Tuesday February 5, 2019
Medway Planning and Economic Development Board
155 Village Street
Medway, MA 02053

DPS Building Site Plan – Public Hearing Continuation

Site Plan Approval - Response to Peer Review Comments

SITE PLANS - NEW DEPARTMENT OF PUBLIC SERVICES BUILDING

EXISTING
CONDITIONS
PLAN I

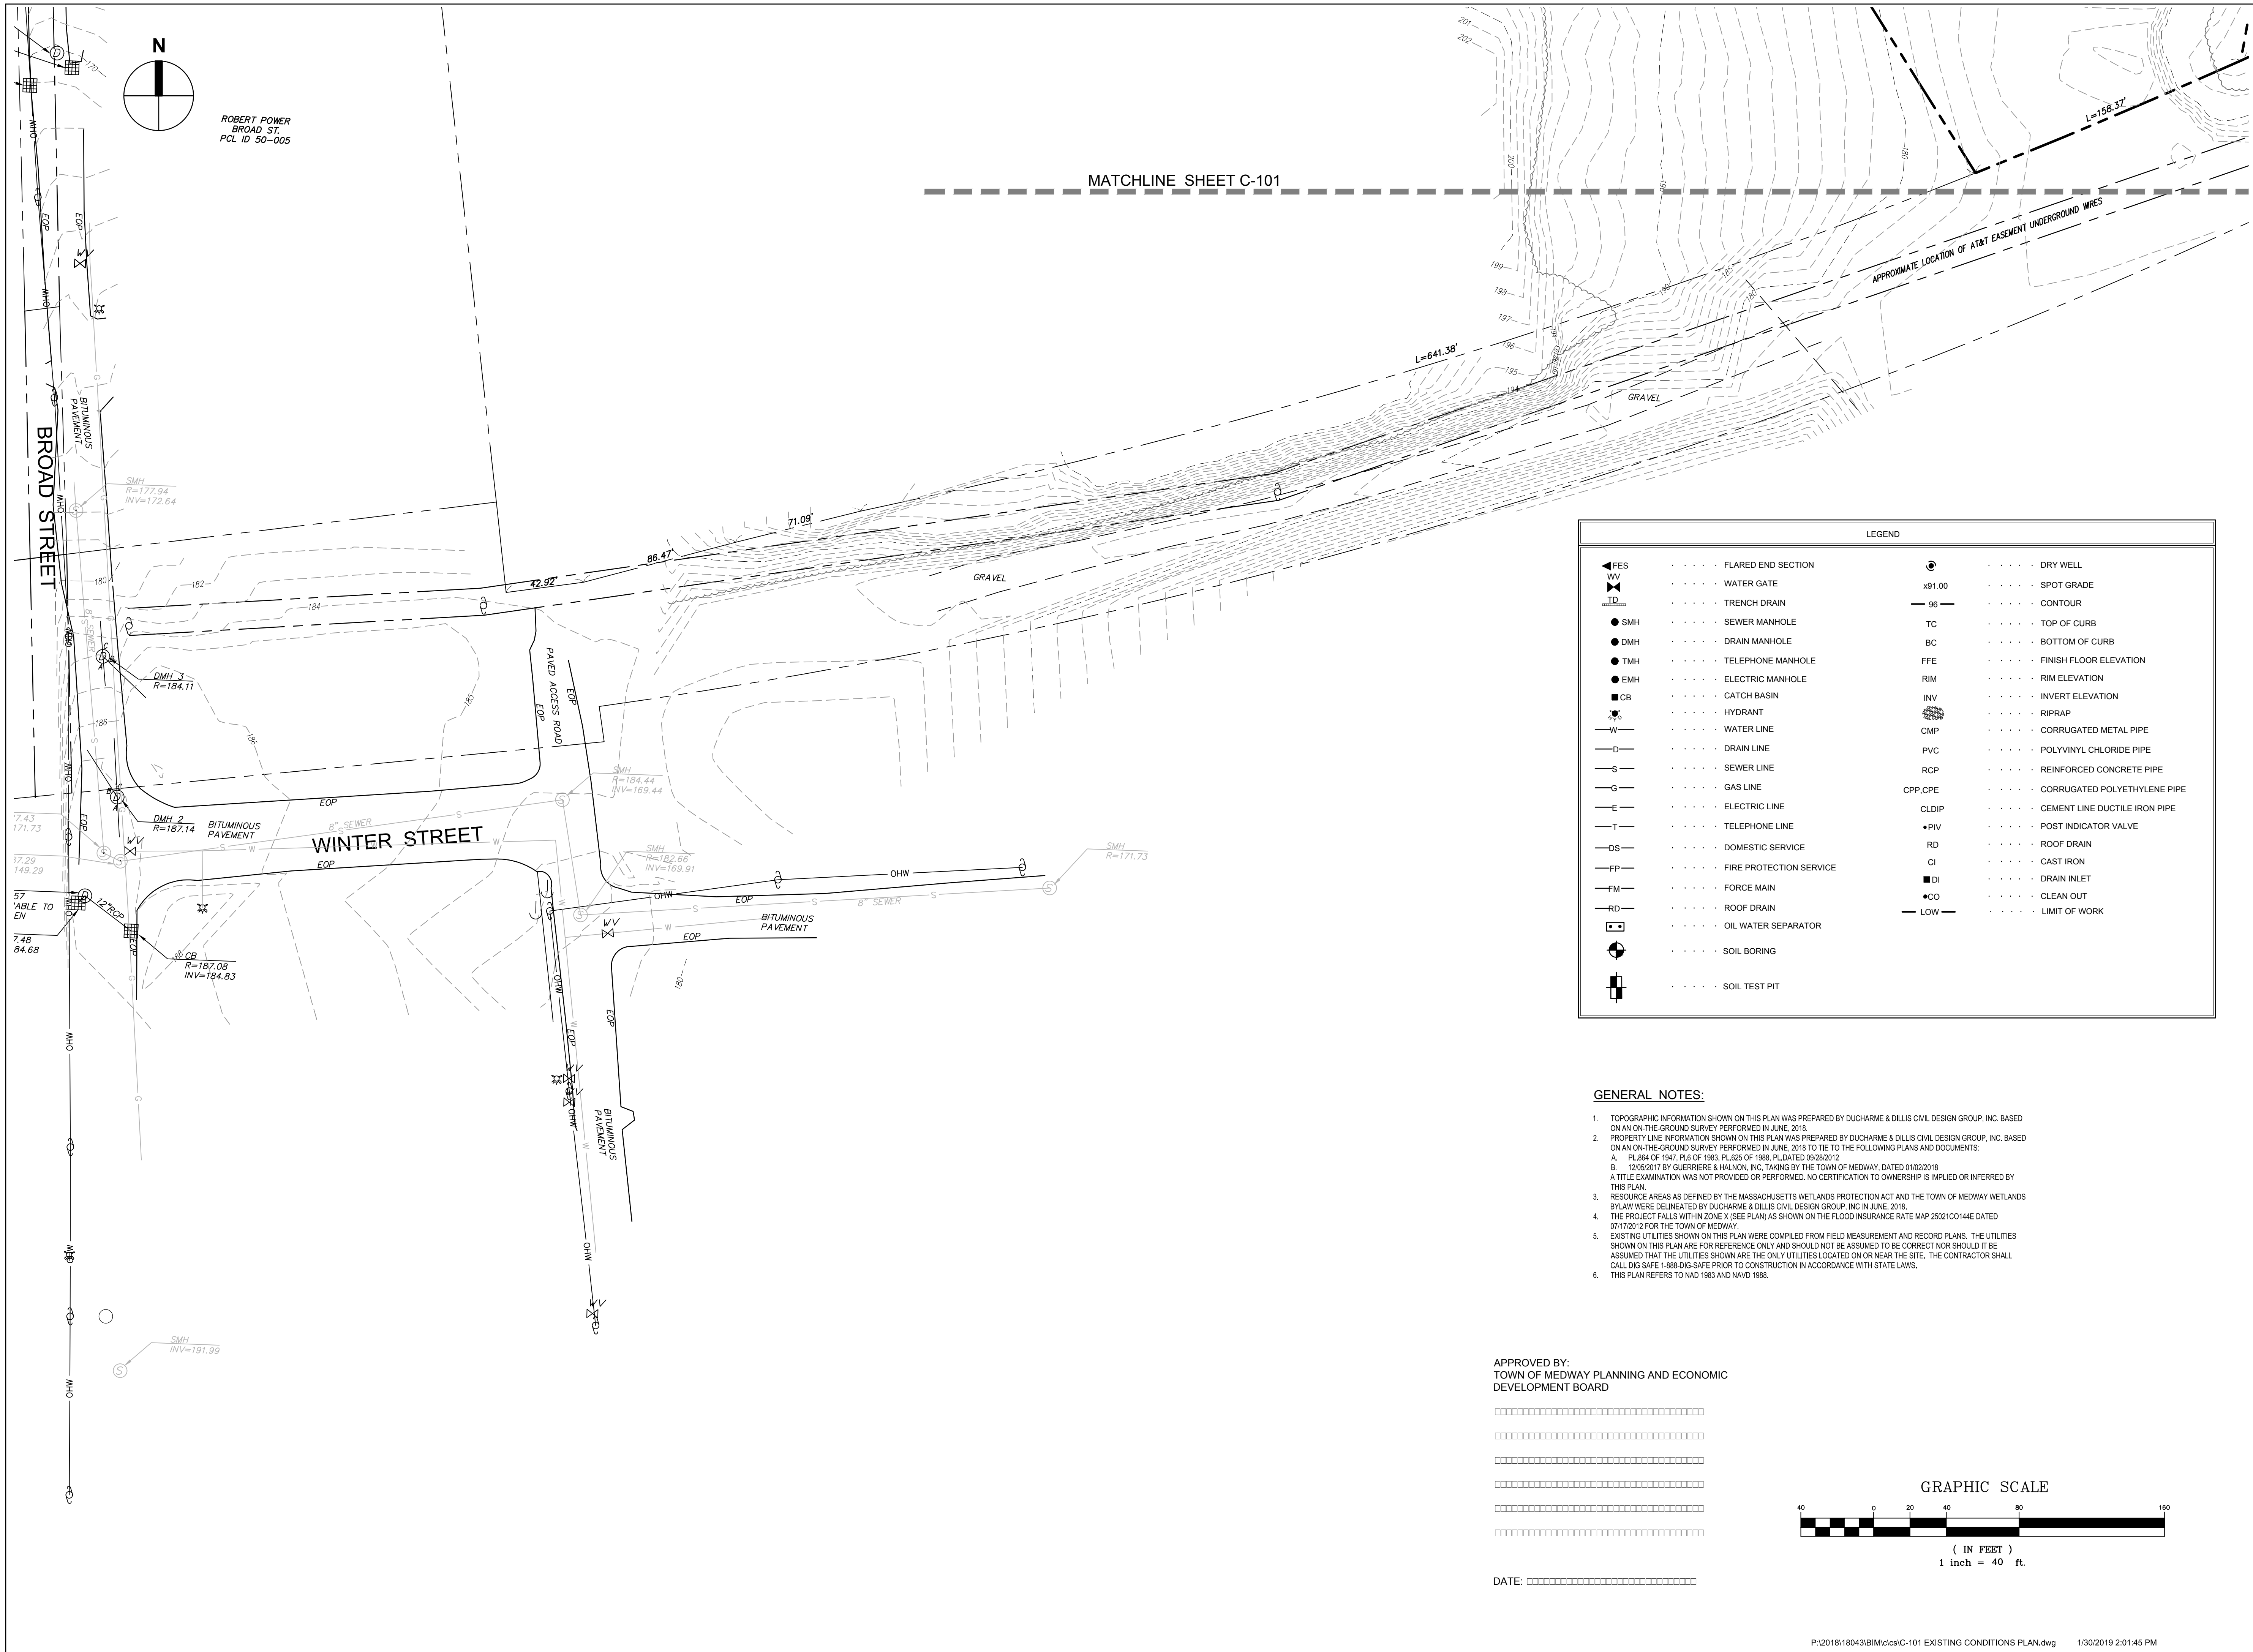
4) Existing underground utilities are not shown on the Existing Conditions Plan I, Sheet C-101. (Ch. 200 §204-5.C.1)

Response: The existing underground utilities to the extent available from record plans and as field surveyed are shown on Sheet C-101.

LAYOUT &
MATERIALS
PLAN

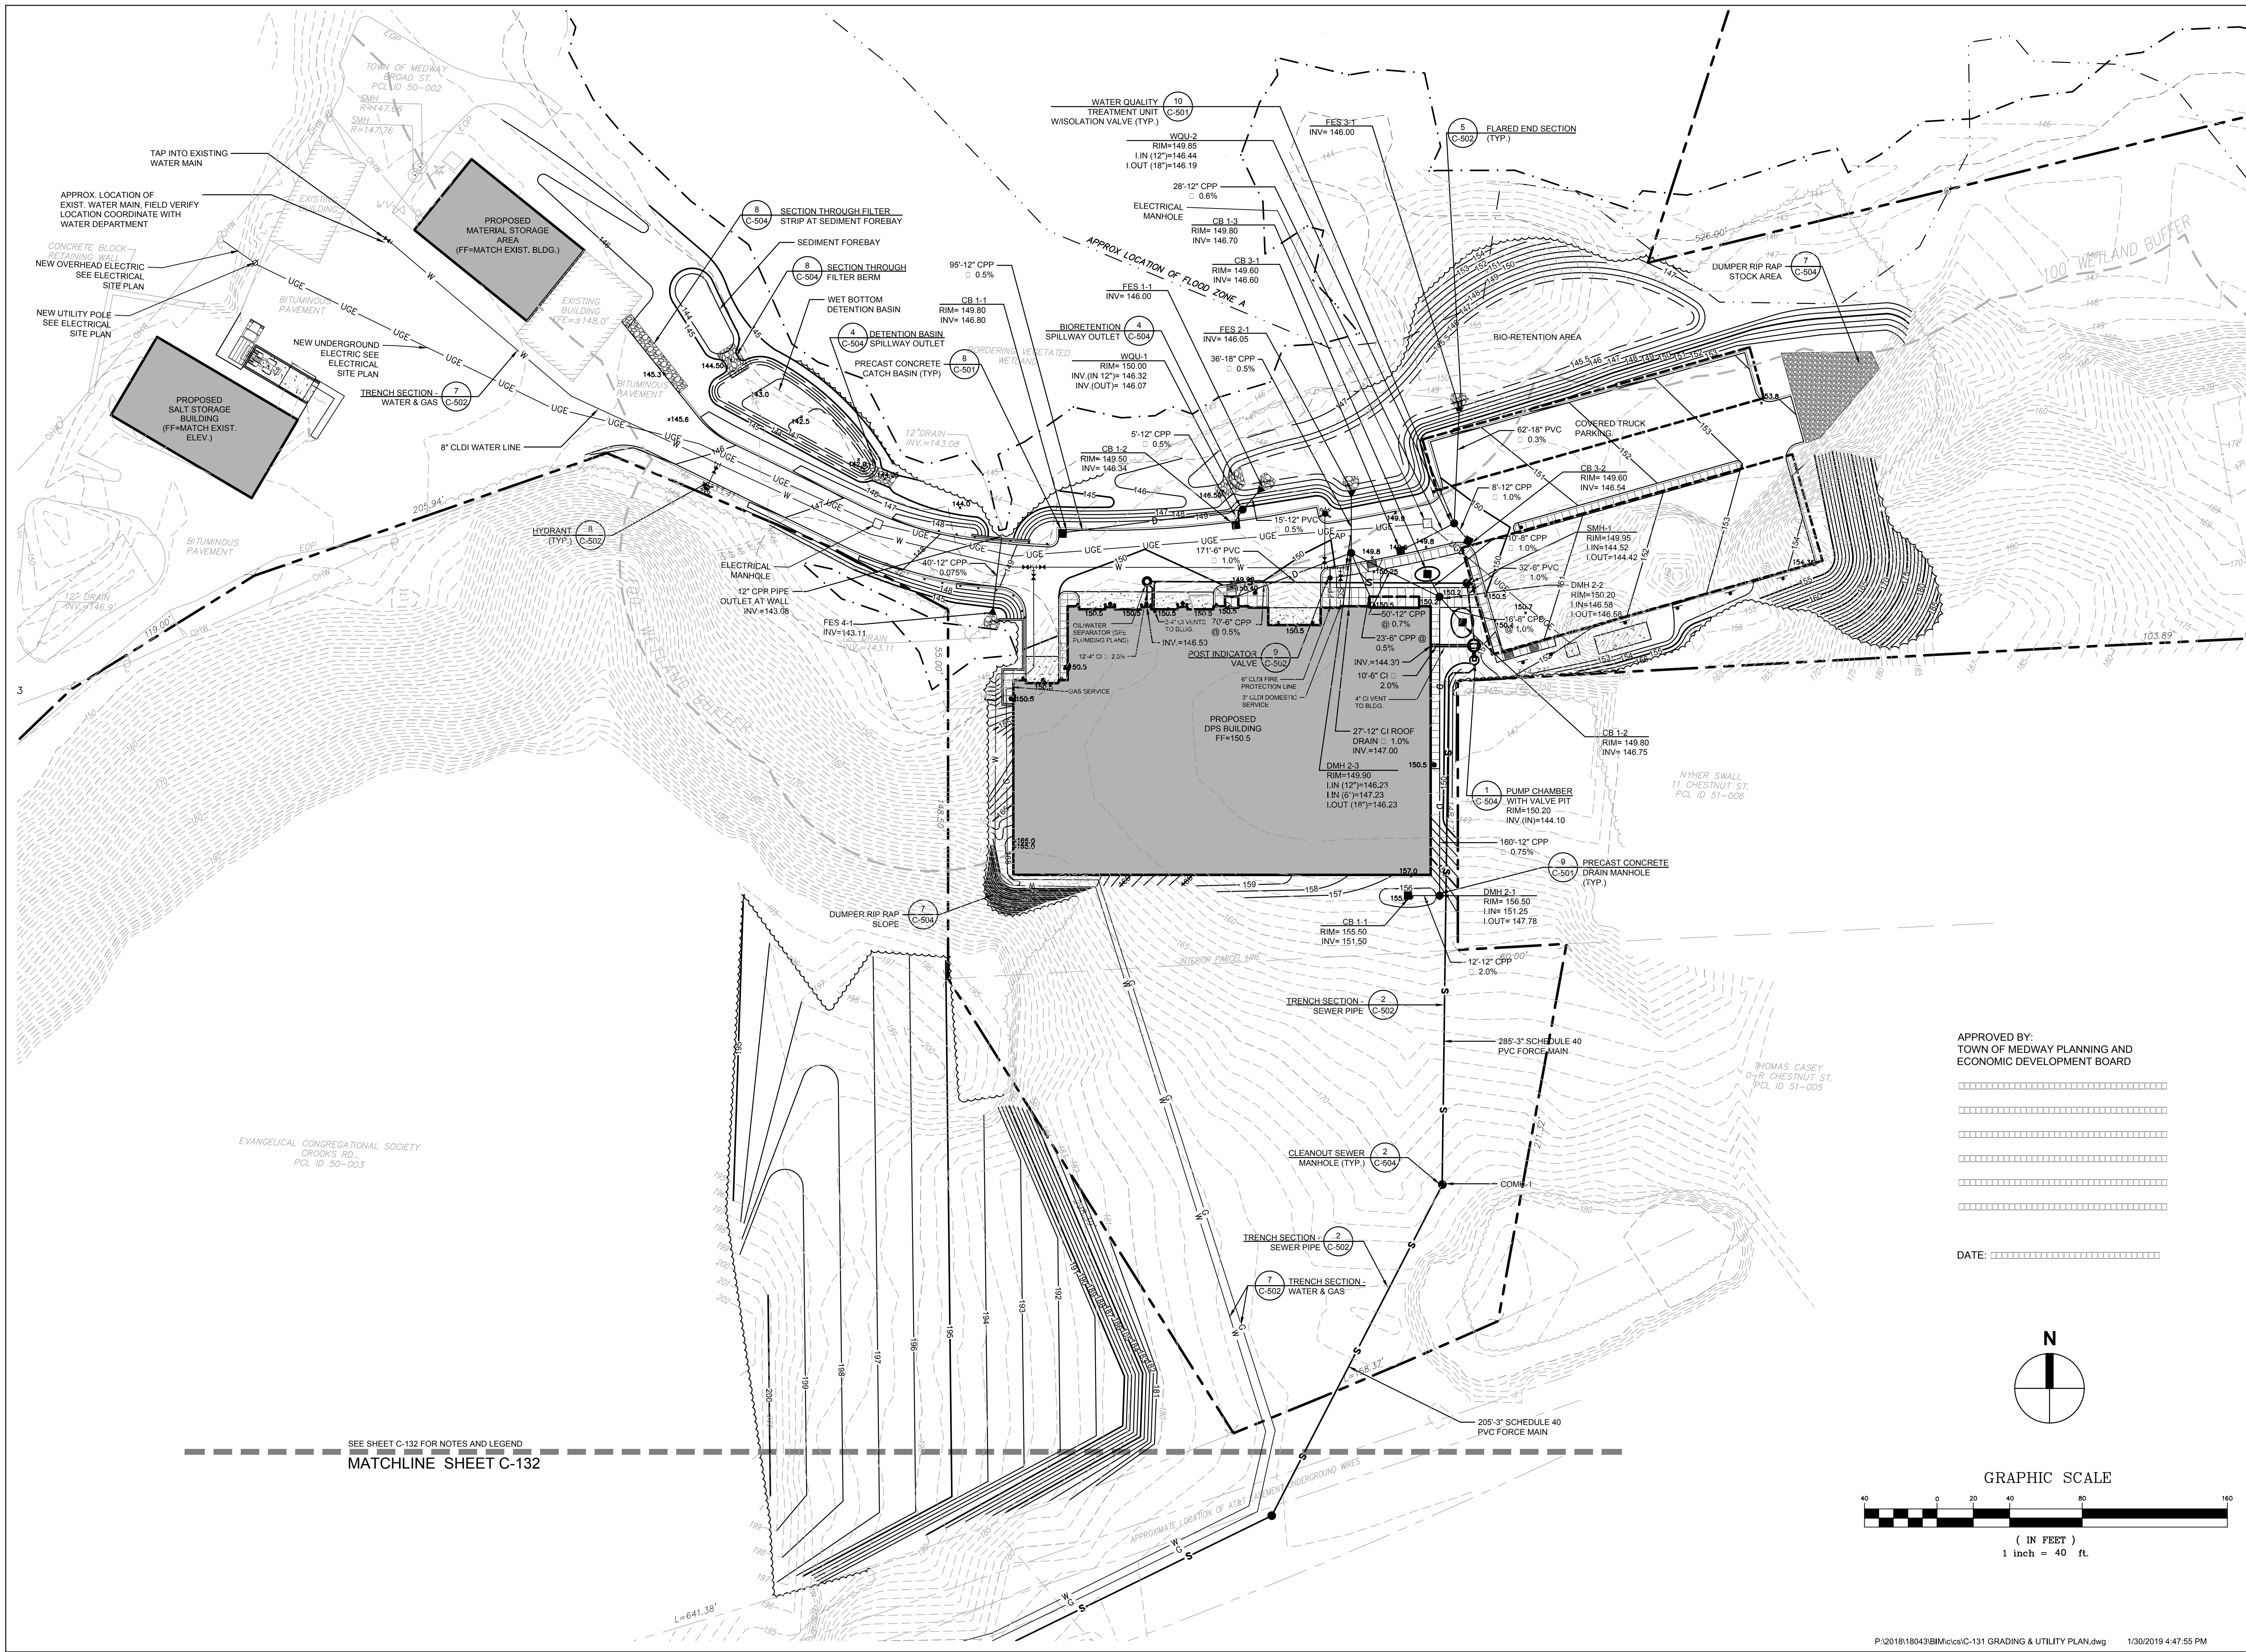
17. The zoning table on the Layout and Materials Sheet shows the district as "Industrial Highway." This should be corrected.

- 11) The table outlining the proposal's conformance with zoning requirements is titled with "Industrial Highway (IH)," a zoning district not found in Medway. Please change the zoning district to "Agricultural Residential I (AR-I)" and confirm the zoning requirements in the table are correct. (Ch. 200 §204-5.D.15)

Response: The Zoning District was corrected on the enclosed Drawing C-121.

Response: The Zoning Table on Drawing C-121 has been revised to show the Agricultural Residential Zone.

DRAWING NO.
C-131

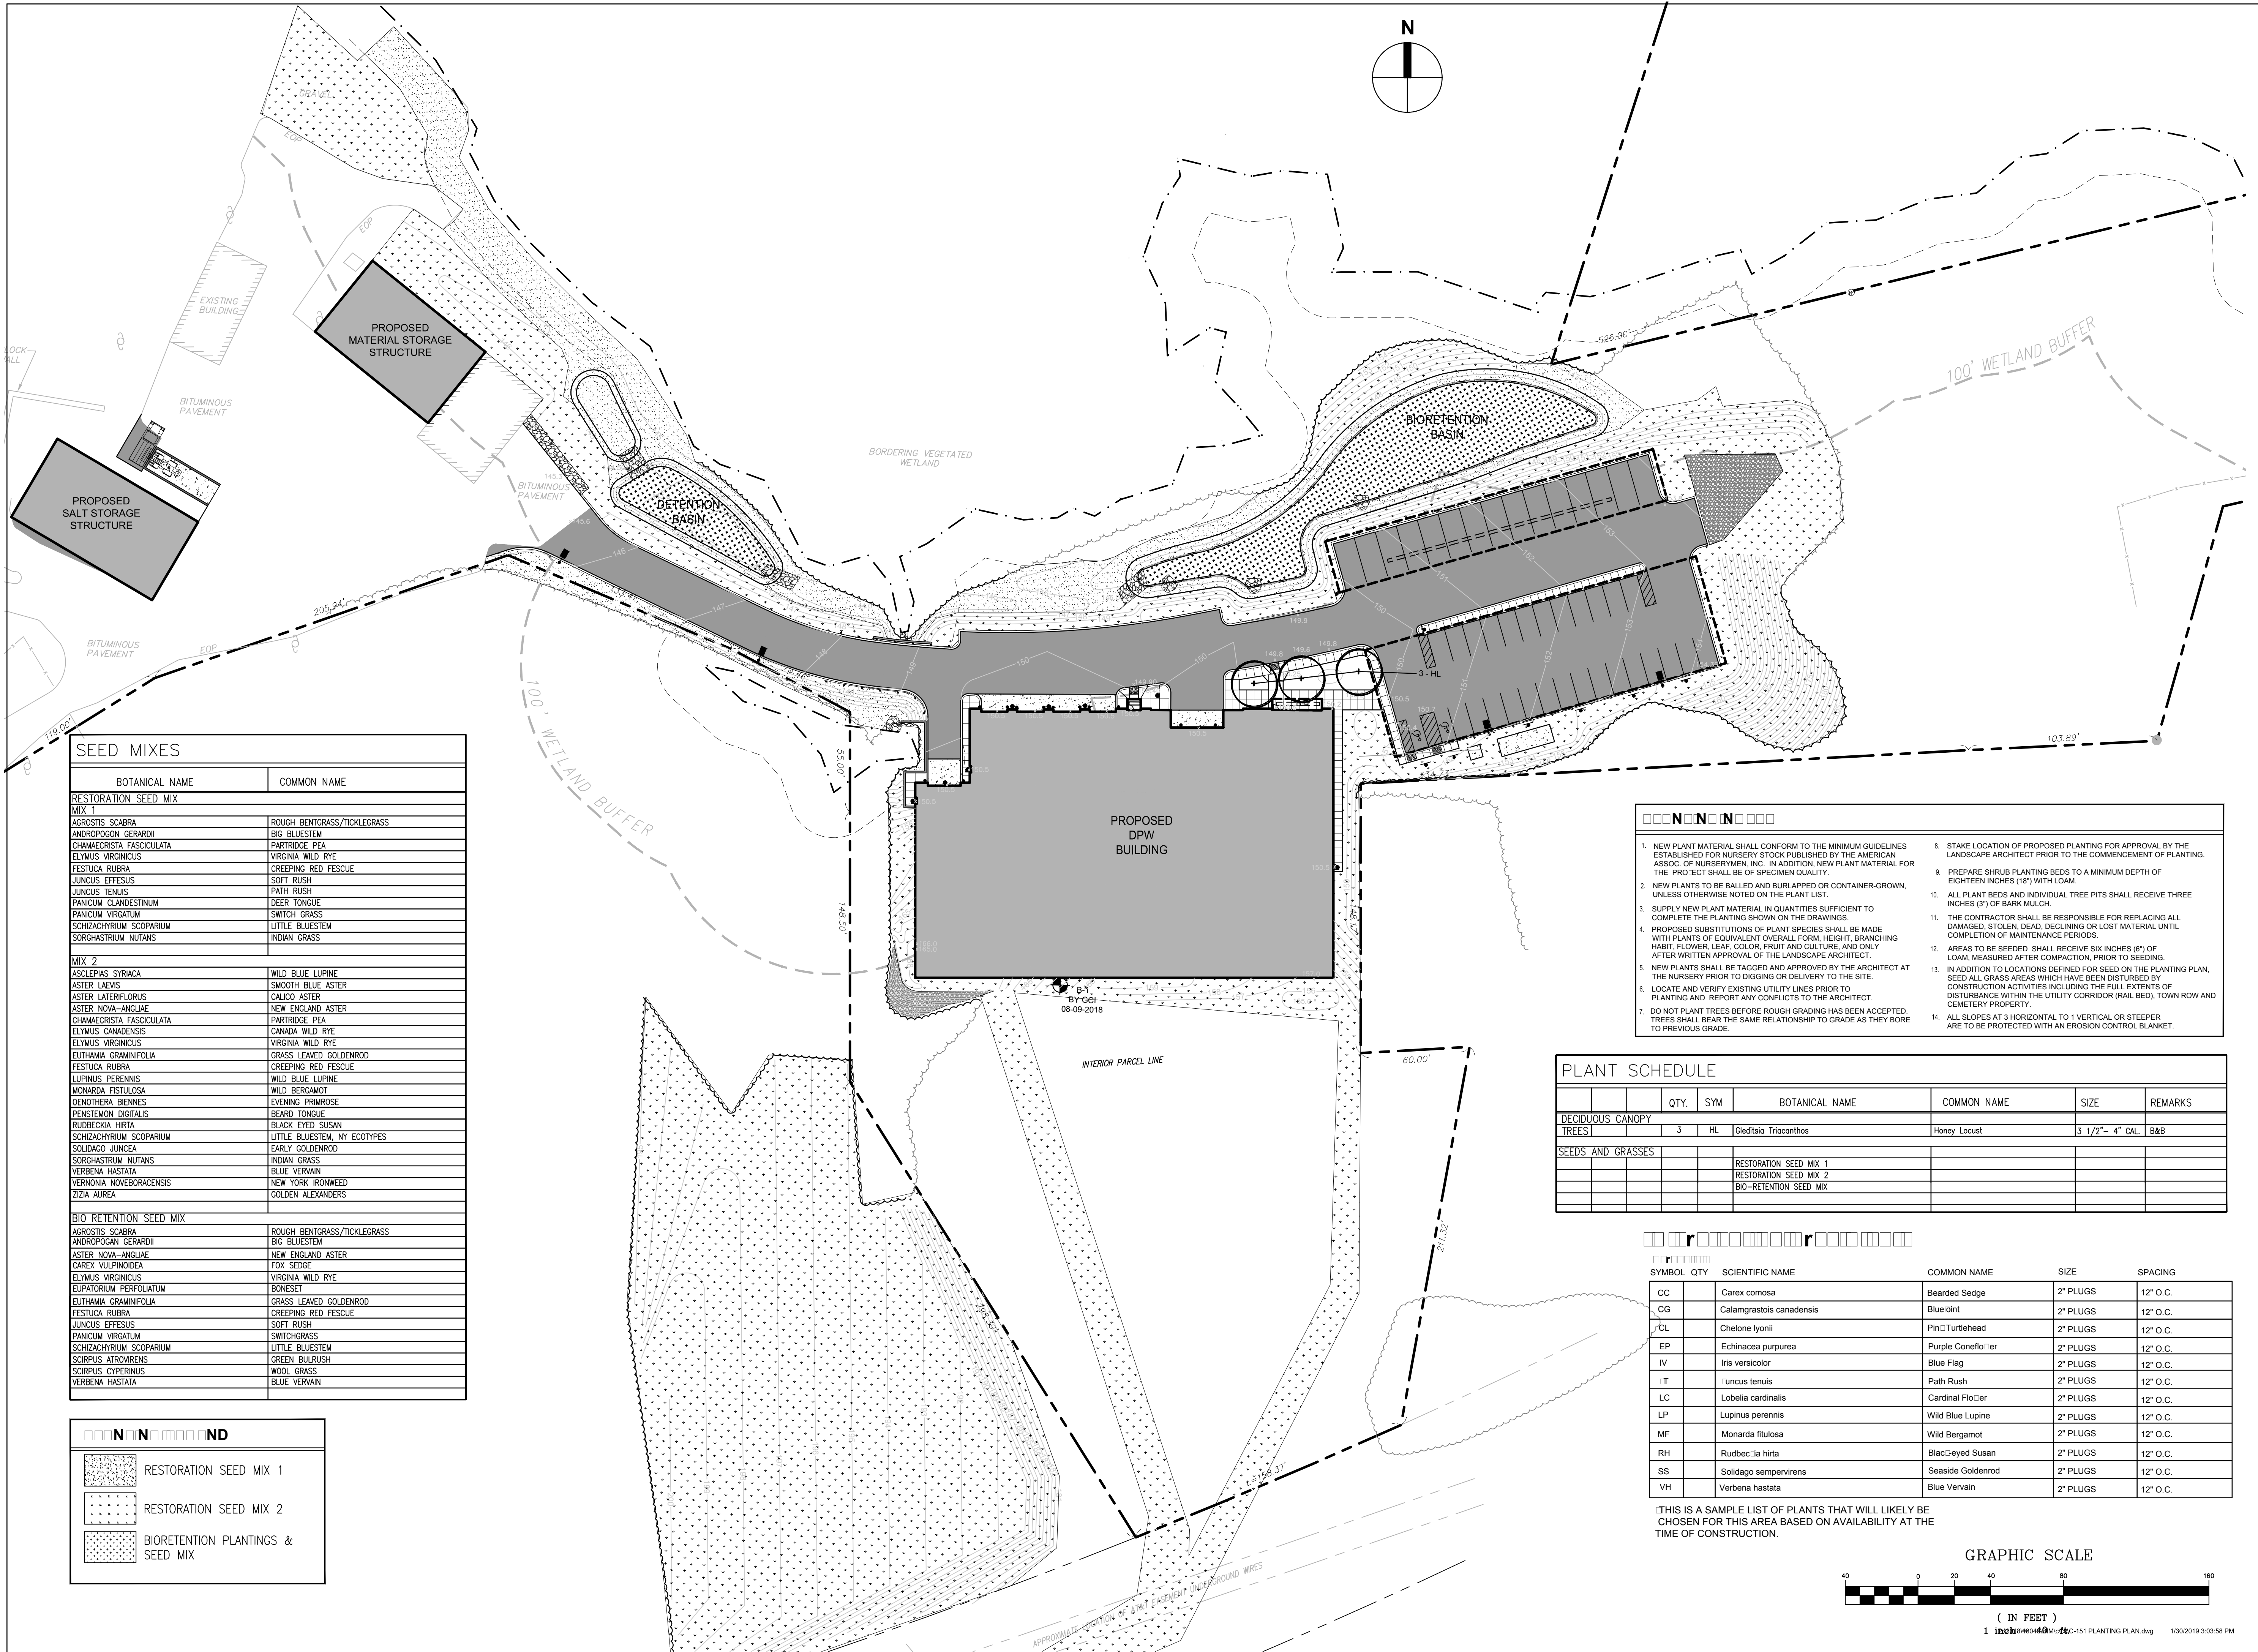
8) Proposed contours have not been provided on Grading and Utility Plan. (Ch. 200 §204-5.D.4)

Response: Proposed contours have been added to Drawing C-131 and C-132.
